**ANSI/ASHRAE Addenda c, d, i, and p to  
ANSI/ASHRAE Standard 62.1-2007**

## **Ventilation for Acceptable Indoor Air Quality**

**Addendum d to 62.1-2007**

**TABLE 5-2 Airstreams**

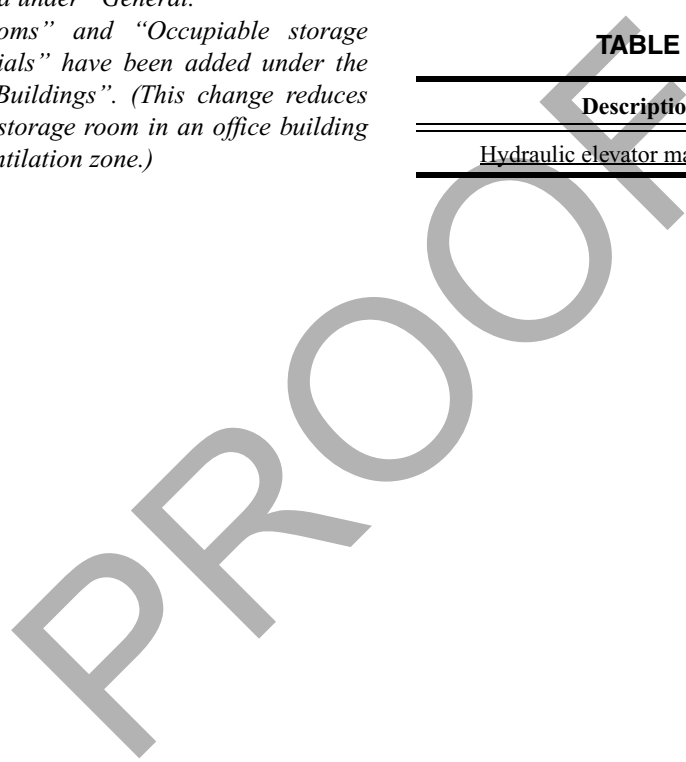
Add the following to Table 5-2:

<b>Description</b>	<b>Air Class</b>
<u>Hydraulic elevator machine room</u>	<u>2</u>
